CERTIFICATE OF APPROPRIATENESS

Property: 805 Franklin Street, Lots 3, 4, & 5, Block 16, SSBB Subdivision. The property is a vacant lot situated on a 15,002 square foot (150' x 100') corner lot.

Proposal: New Construction – This project was deferred at the July and August 2016 HAHC meetings so that the applicant could further work with staff.

**EXAMPLES OF VERTICALITY AND WINDOW RHYTHM WITHIN THE DISTRICT**

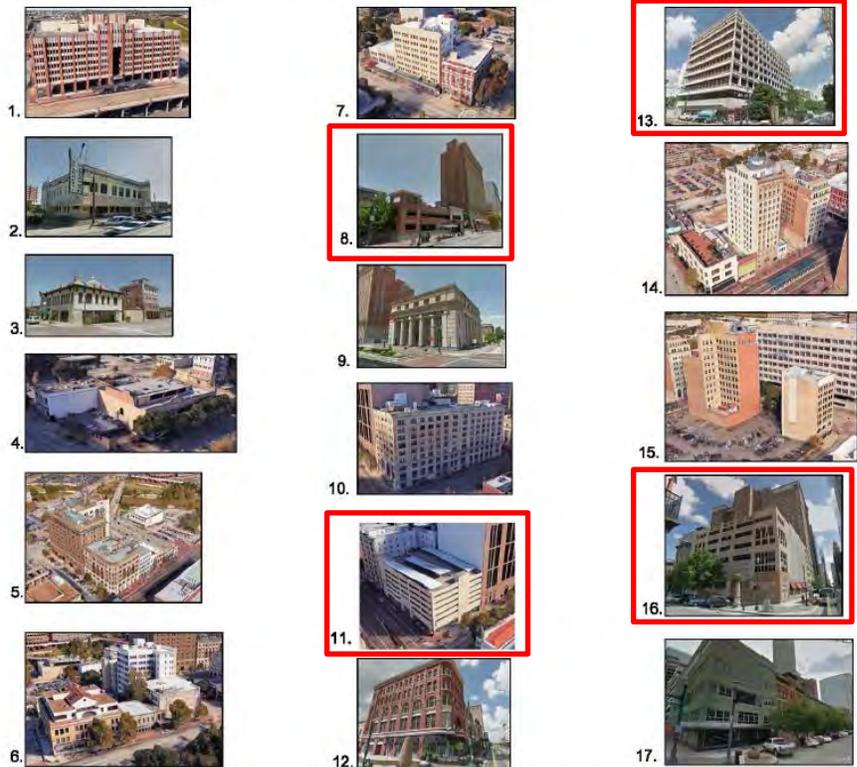
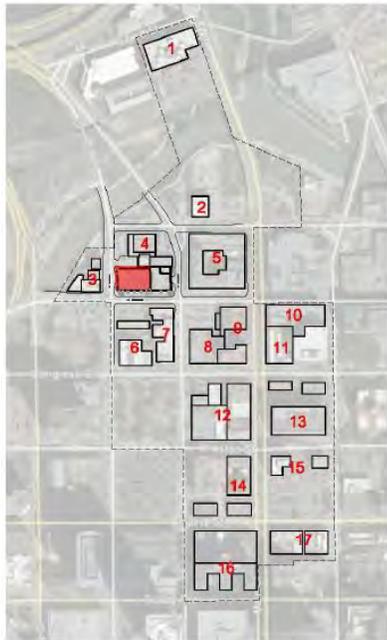
During a meeting with the applicant, staff explained that it is not just the verticality that is important in the overall design of this structure. We explained that the verticality is a dominant feature in any of the tall historic structures within the district, along with a fenestration rhythm and distinct bays, cornice lines, awnings, and ground floor storefronts.

We emphasized that the horizontal parking decks should be masked and suggested methods including screens, false fronts, and curtain walls. In conjunction with creating a more typical rhythm, elements such as decorative exterior fins or other features could be added to increase the sense of verticality. None of these suggestions are stand-alone items and should be used in conjunction with other methods.

Staff also recommended that both the ground floor and the cornice be differentiated from the body of the building, which would lend a more traditional appearance to the building, even if the building still reads as a garage. We particularly noted that the ground floor should be emphasized or differentiated from the body of the building because of the pedestrian character of the historic district. Staff's suggestion was to design a ground floor that reflects the characteristics of historic building storefronts found throughout Main Street Market Square, as well as the use of a prominent suspended awning over the sidewalk. This would both help enhance the pedestrian experience, be compatible with other historic structures in the district, and would partially obscure the upper floors of the garage from the ground level. Staff also suggested that the applicants speak with the owners of neighboring properties to get their opinions on the proposed design.
